INDESIT company

Model type:
BAN12W

Commercial code:
F044458

N1030093fig1

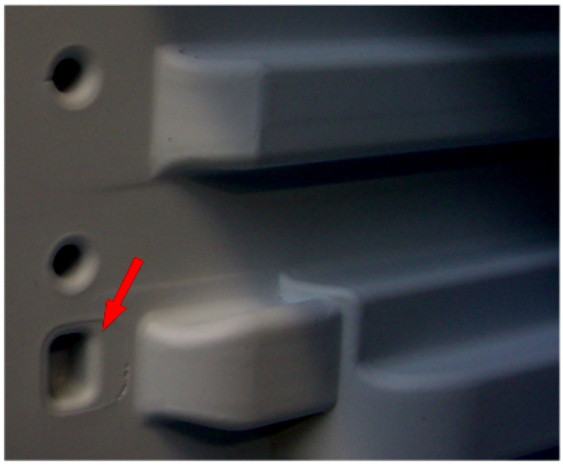
n1030093: New fixing of evaporator on static fridge-freezers (05 range) 60 cm,Melano

From August 05 (serial no. 50802.0001) the freezer evaporator is secured to the cabinet by a plastic profile.
The cabinet walls have been modified to create locations to house the profile, which is installed on the front of each evaporator plate (see photo N1030093fig1- fig2 - fig3)
The profile cannot be fitted on premodification appliances, so technical personnel must continue to fit the rh and lh supports on these models (see photo N1030093fig4)

New parts
C00141135 = WHITE PROFILE L=443.5 MM

Parts replaced
C00075596 = EVAPORATOR RH SUPPORT
C00075597 = EVAPORATOR LH SUPPORT
